Enclosed is a copy of the Crissy Field Plan Staff Report and Finding of No Significant Impact (FONSI). The FONSI completes the environmental review process for this project.

FINDING OF NO SIGNIFICANT IMPACT CRISSY FIELD PLAN

SUMMARY OF PUBLIC COMMENT

Parking Proposed in Presidio GMPA and Crissy Field Plan

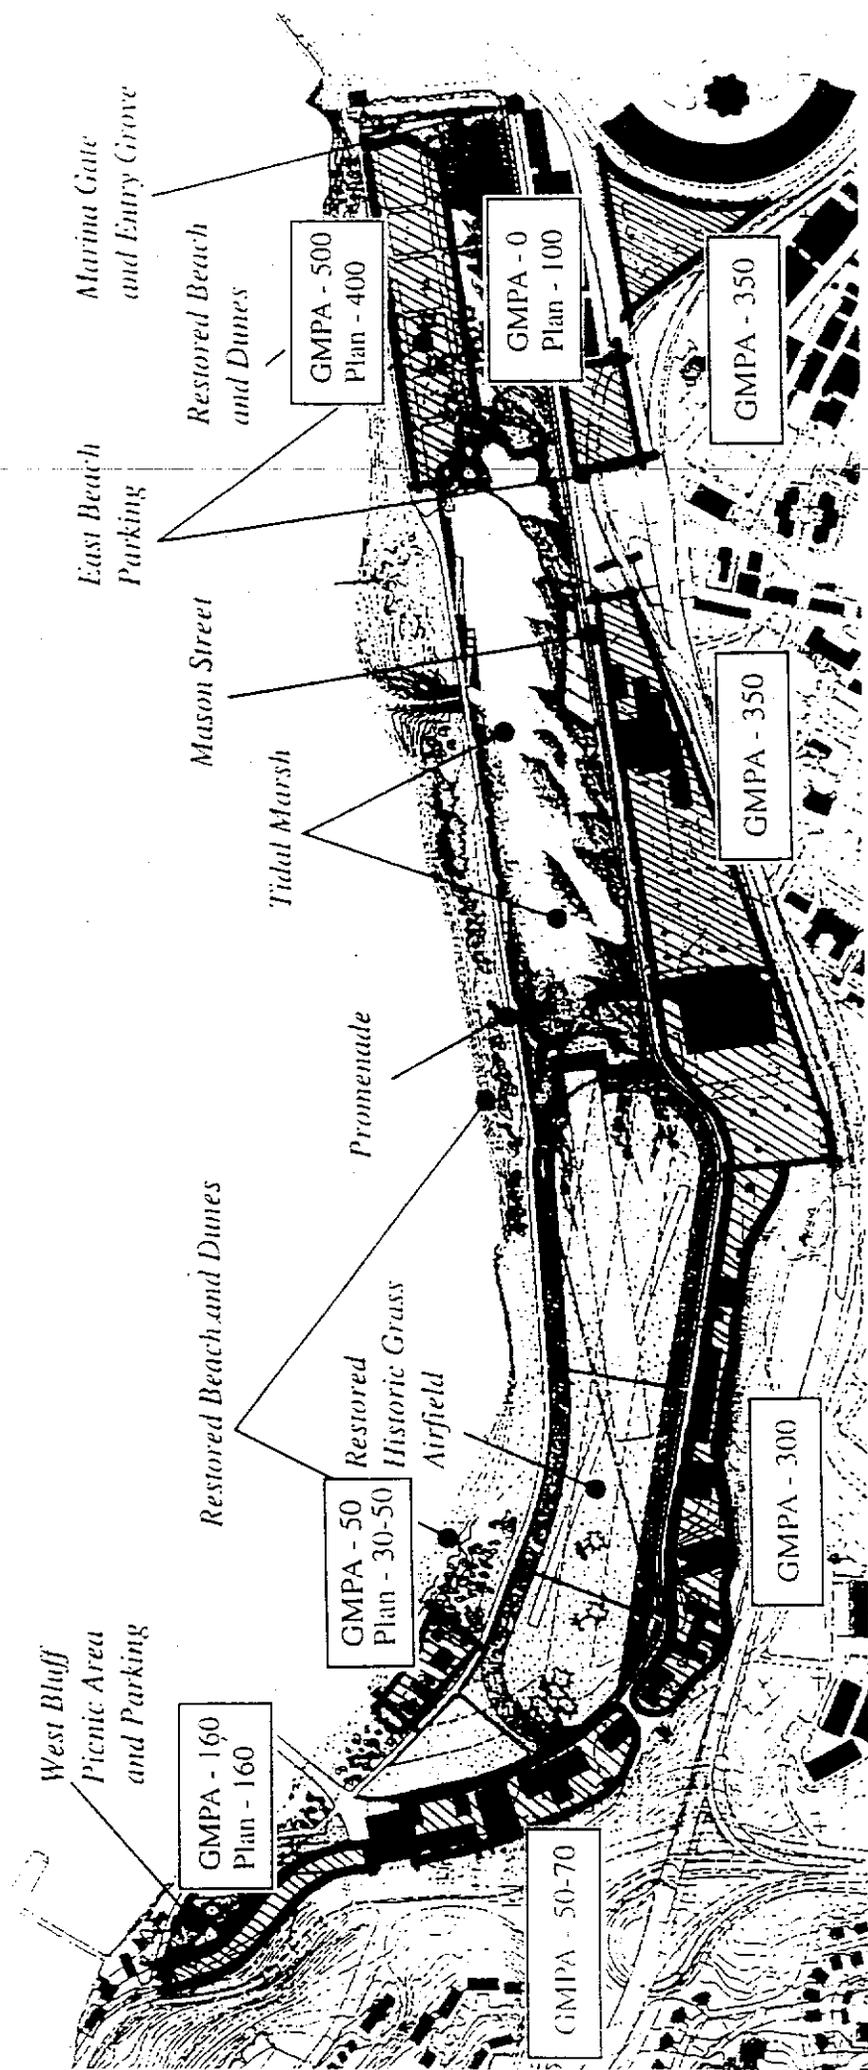
4. Clarify the parking information in the EA, and how it relates to the GMPA/EIS parking. Discuss location of special event parking and how it will be accommodated. The City of San Francisco Planning Department letter raised these issues. (Figure 1)

Parking provided for in the proposed action is consistent with the parking needs identified in the GMPA. The GMPA calls for 1,760 parking spaces in the entire 150-acre Crissy Field planning area, which includes about 50 acres south of Old Mason Street - outside the scope of the proposed action. The GMPA recommended a distribution of parking spaces throughout Crissy Field in relation to anticipated demand. That allocation called for about 500 spaces at east Crissy Field, about 350 in the vicinity of the Palace of Fine Arts, about 350 spaces near the Commissary south of Mason Street, about 300 spaces south of Old Mason around Stillwell Hall, and about 260 spaces at the west end of the historic airfield extending out to Torpedo Wharf.

The traffic impacts analysis for the Crissy Field EA verified that travel demand, and therefore parking demand for the proposal in the EA was consistent with projections in the GMPA. The Crissy Field plan provides 400 of the 500 recommended east Crissy parking spaces north of Mason Street, and the remaining 100 spaces south
